Reviewed for Code Compliance
 Permitting and Inspections Department
 Approved with Conditions

WAGLEOD
 275 Park Street, 3rd
 Portland, ME 04103
 SECOND FLOOR ADDITION
 11/21/2018

SECOND FLOOR ADDITION
21 STUART STREET
PORTLAND, MAINE

PROPOSED SECOND FLOOR PLAN

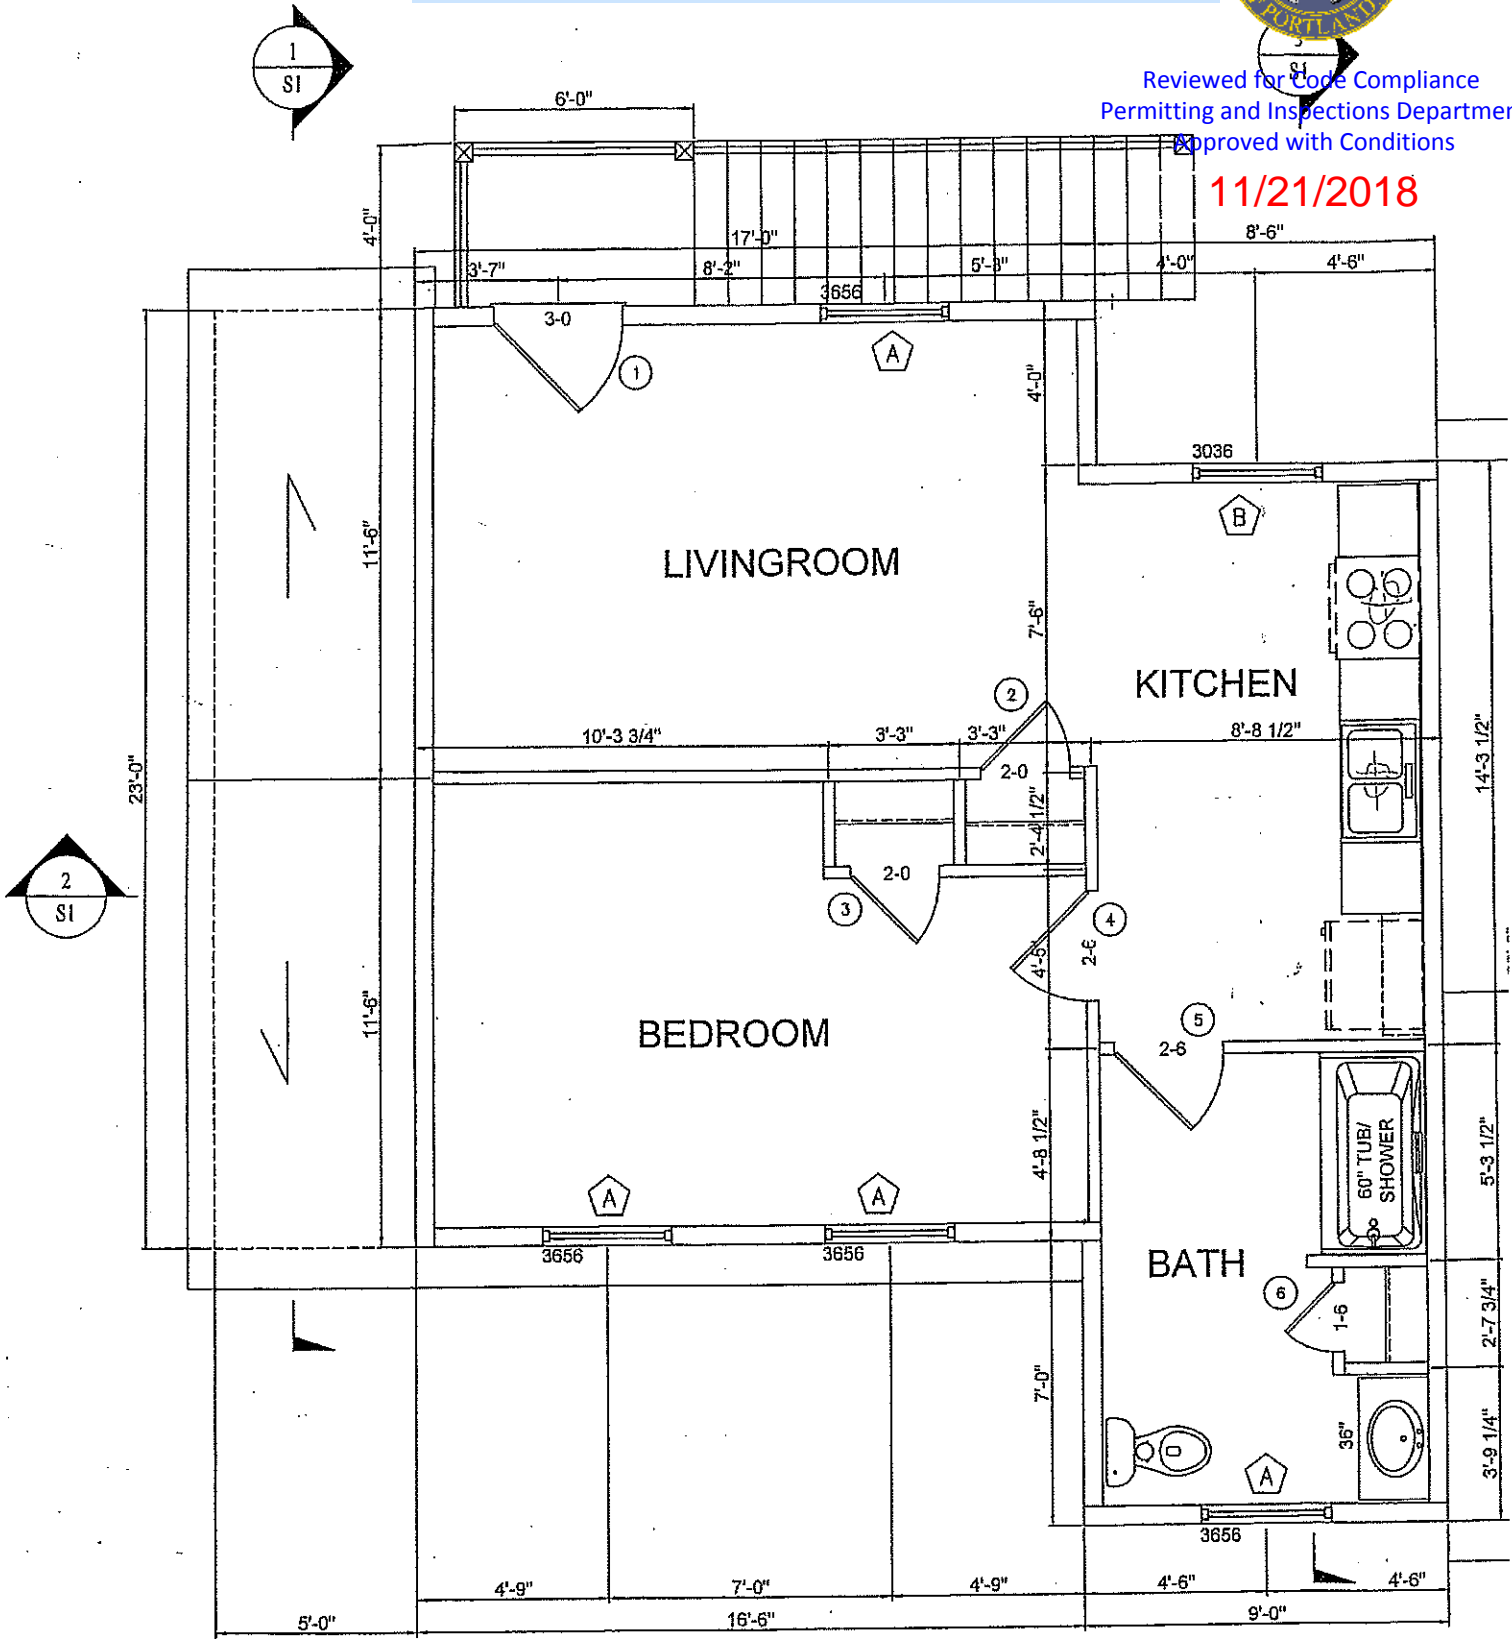
The addition of the new dwelling unit requires that the entire building be sprinkled. Please note on the drawing that an NFPA-13D system will be installed throughout.
